NOTE OF INFORMATION

| To : All Bidders | Project : MTEC SNESI KONDRE |
| Date : 08 January 2025 | Project # : EMSAGS-0824-C |
| | Ref. : MTEC-0824-C-MoM01 |

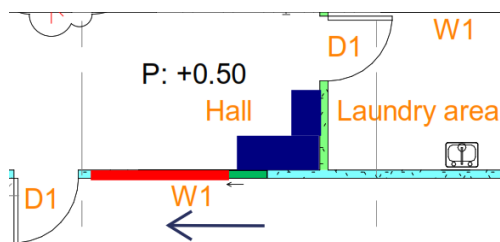
13. Is the Storage Room in the floor plan drawing of the electrical system intended for the Solar Installation?

Answer: No, the installation (in blue) will be done in the hall and the window will be moved towards the door. Measurements to be checked onsite. See picture for the location.
